SERVICE BULLETIN

FUJI HEAVY INDUSTRIES LTD.

NO. 200-010 DATE March 6, 1992 (SUPERSEDES NO.)
REV. DATE (SUPERSEDES NO.)
REASON

1. SUBJECT : HORIZONTAL STABILIZER FORWARD SPAR WEB, INSPECTION AND REPAIR OF
2. AIRCRAFT AFFECTED : All FA-200 series aircraft prior to S/N 12.
3. PRIORITY : Mandatory
4. REASON : Since there has been an instance reported whereby cracks occurred on the horizontal stabilizer forward spar web (center area), inspection and (if necessary) repair are required for the affected area.
5. DESCRIPTION : Visually inspect the horizontal stabilizer forward spar web for cracks. If inspection reveals crack(s), add both repair doubler and reinforcement doubler. If no cracks are found, install reinforcement doubler only.
6. ACCOMPLISHMENT : Immediately upon receipt of this bulletin.
7. APPROVAL : JCAB approval (No. Tokyo-3-010) February 17, 1992
8. PARTS REQUIRED : The following parts are required to comply with this bulletin:

FIGURE 1

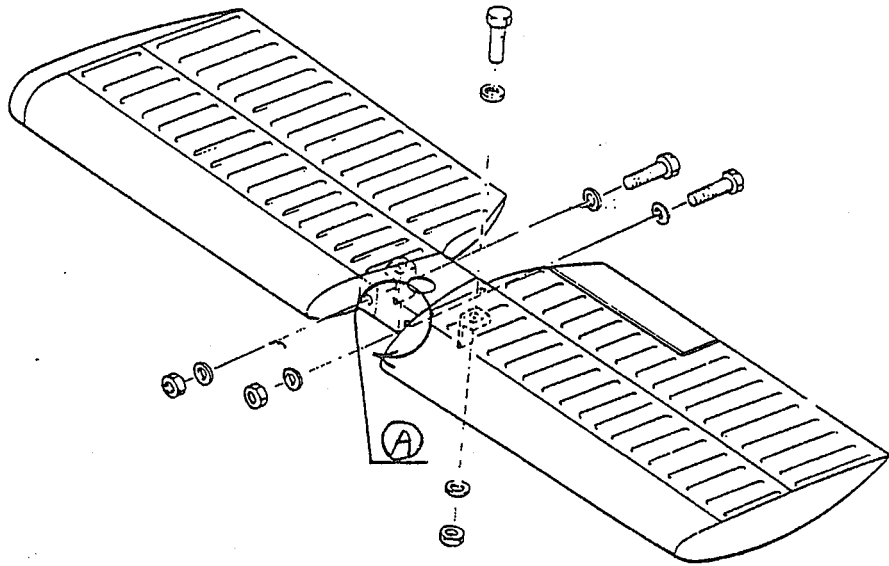
- (1) Remove horizontal stabilizer in accordance with Service Manual, para 7-6.
- (2) Visually inspect the center area of horizontal stabilizer forward spar web for cracks, paying particular attention to the circled A area as shown in the figure 1.

FIGURE 2 MODIFICATION OF HORIZONTAL STABILIZER FORWARD SPAR WEB (IF NO CRACK FOUND)

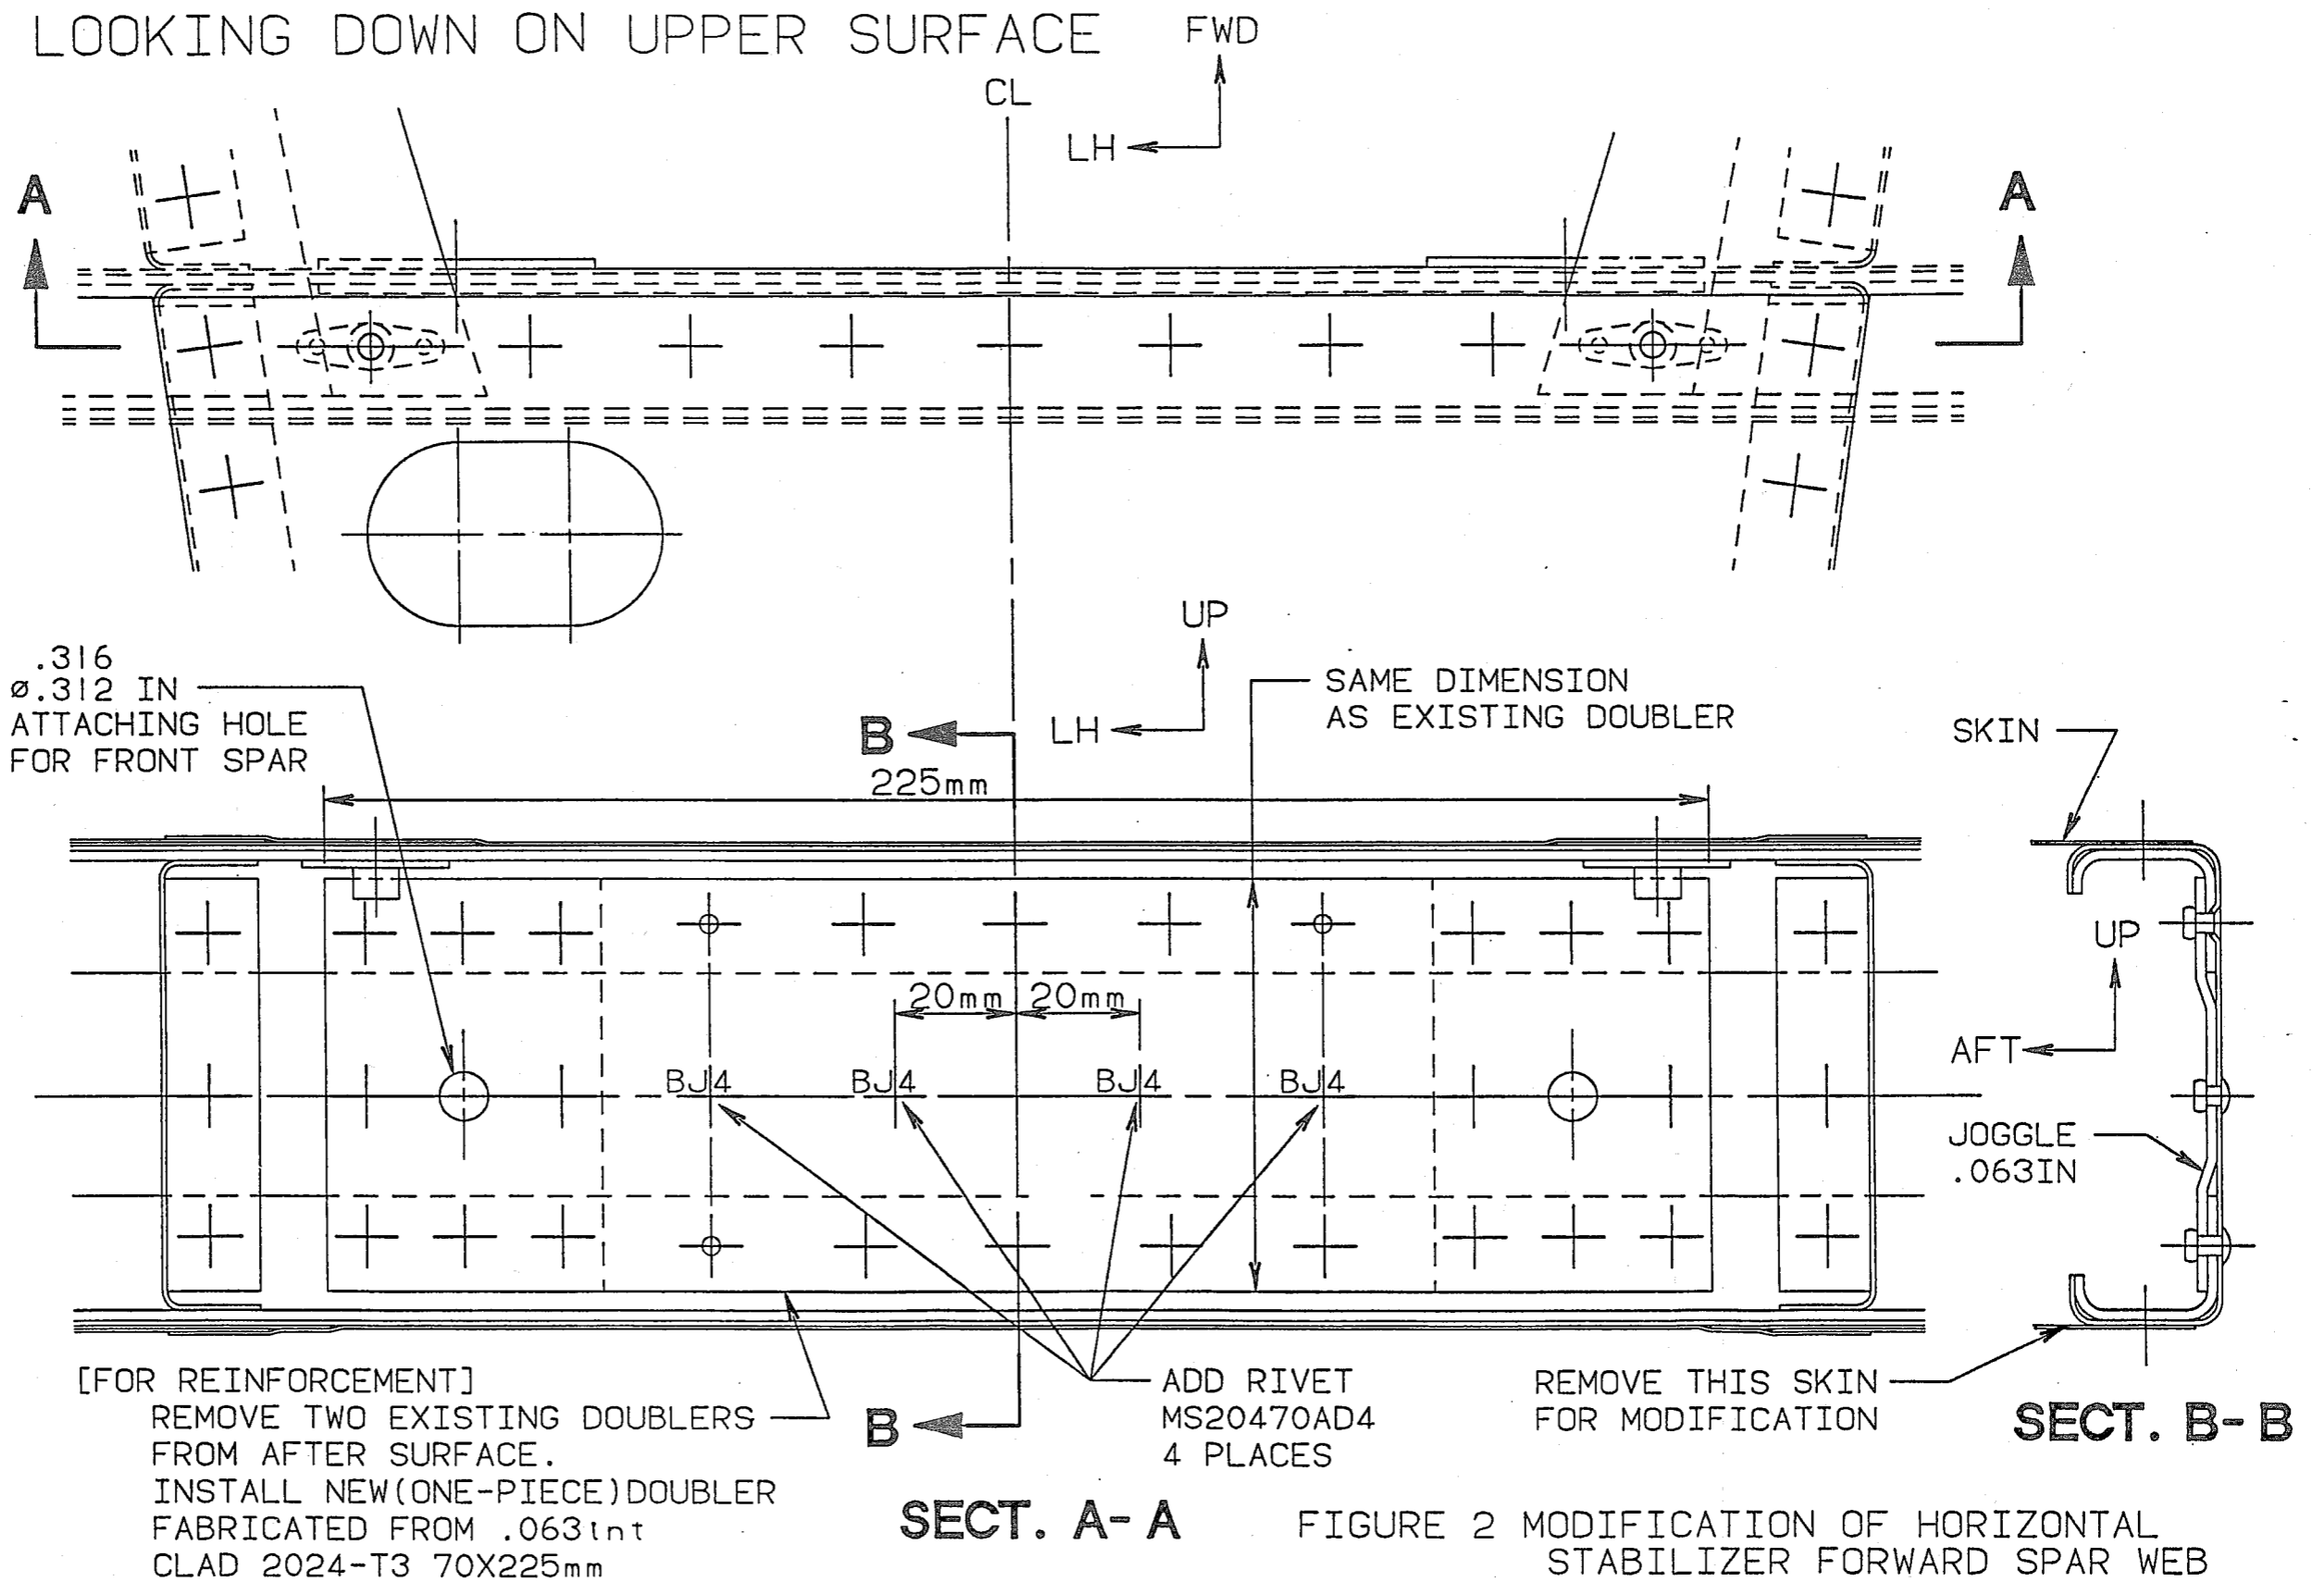
- (3) If no cracks are found, modify the forward spar as follows (see figure 2):
 - (a) Remove lower center skin located between forward and afterward spars.

- (b) Remove two existing doublers from the aft surface of horizontal stabilizer forward spar (center area).
 - (c) Install new doubler in place of the doublers removed in the above step.

- (d) Reinstall lower center skin.
- (4) If crack(s) are found, modify the forward spar as follows (see figure 3):
 - (a) Remove lower center skin located between forward and afterward spars.

FIGURE 3 MODIFICATION OF HORIZONTAL STABILIZER FORWARD SPAR WEB (IF CRACK FOUND)

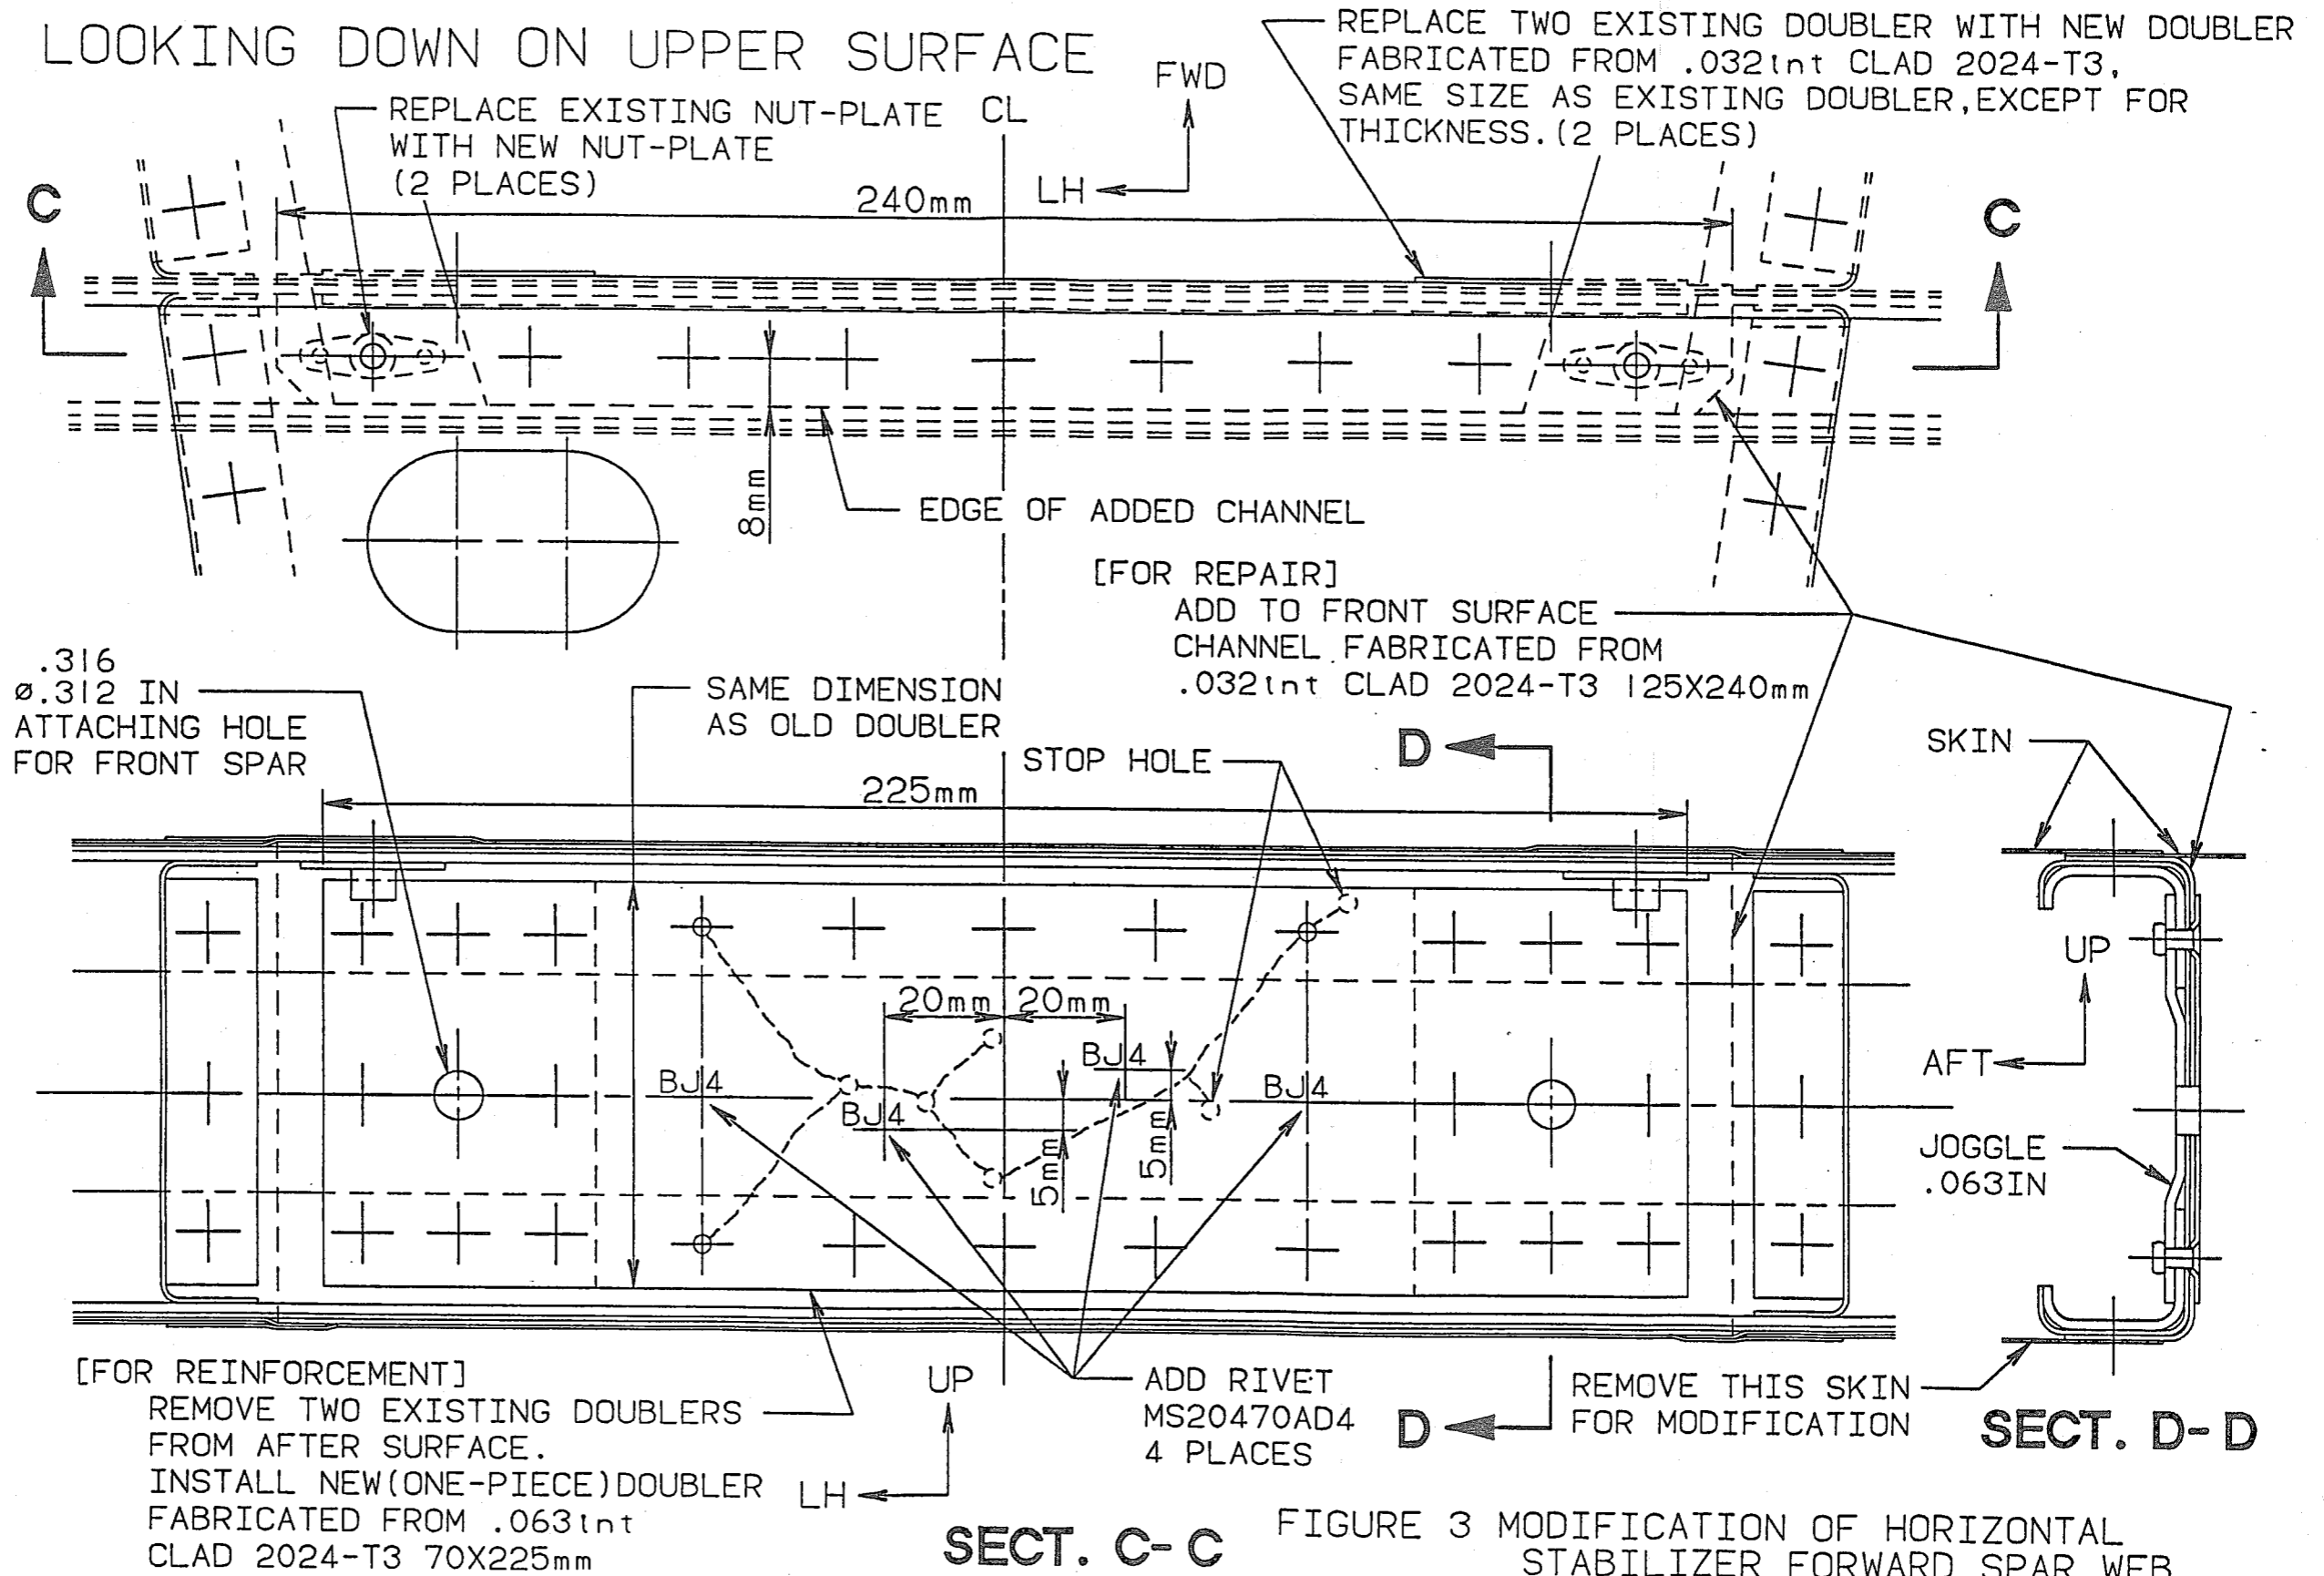
- (b) Stop drill each end of crack.
 - (c) Remove two existing doublers (forward) and two existing doublers (aft) from horizontal stabilizer forward spar (center area).

- (d) In place of the removed doublers, install new doubler on aft surface of the spar. Also install new channel and doublers on forward surface of the spar.

- (e) Reinstall lower center skin.
- (5) Install horizontal stabilizer in accordance with Service Manual, para 7-7.
